**Addendum z to
ASHRAE Guideline 36-2018**

Proposed Addendum z to Guideline 36-2018, High-Performance Sequences of Operation for HVAC Systems

**First Public Review (November 2020)
(Draft shows Proposed Changes to Current Guideline)**

Figure 5.5.5 Control logic for cooling-only VAV zone.

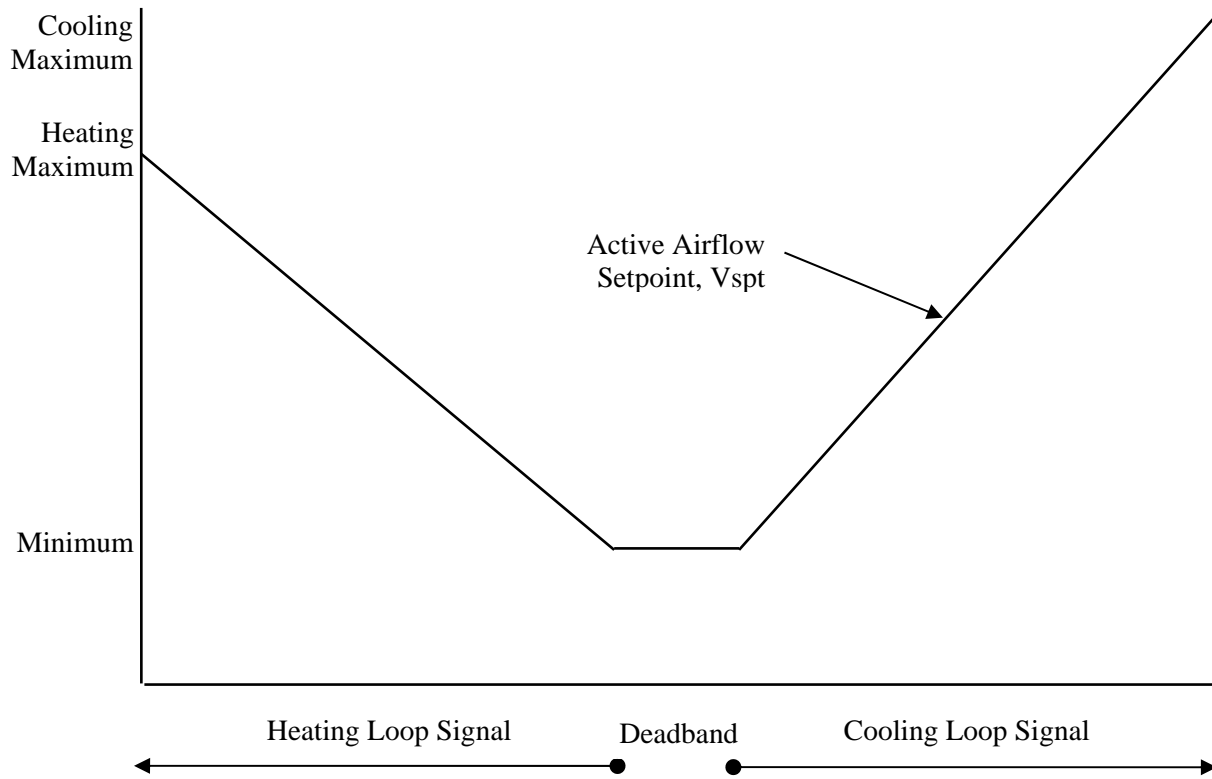
Revise Paragraph 5.5.5 as follows:

5.5.5 Control logic is depicted schematically in Figure 5.5.5 and described in the following subsections.

- 5.5.5.1 When the zone state is cooling, the cooling-loop output shall be mapped to the active airflow set point from the minimum endpoint to the cooling maximum endpoint.

- d. If supply air temperature from the air handler is greater than room temperature, the active airflow set point shall be no higher than the minimum endpoint.

- 5.5.5.2 When the zone state is deadband, the active airflow set point shall be the minimum endpoint.
- 5.5.5.3 When the zone state is heating, the heating loop output shall be mapped to the active airflow setpoint from active airflow set point shall be the minimum endpoint to the heating maximum endpoint.

- a. If supply air temperature from the air handler is less than 3°C (5°F) above the room temperature, the active airflow setpoint shall be no higher than the minimum endpoint.

- 5.5.5.4 The VAV damper shall be modulated by a control loop to maintain the measured airflow at the active set point.
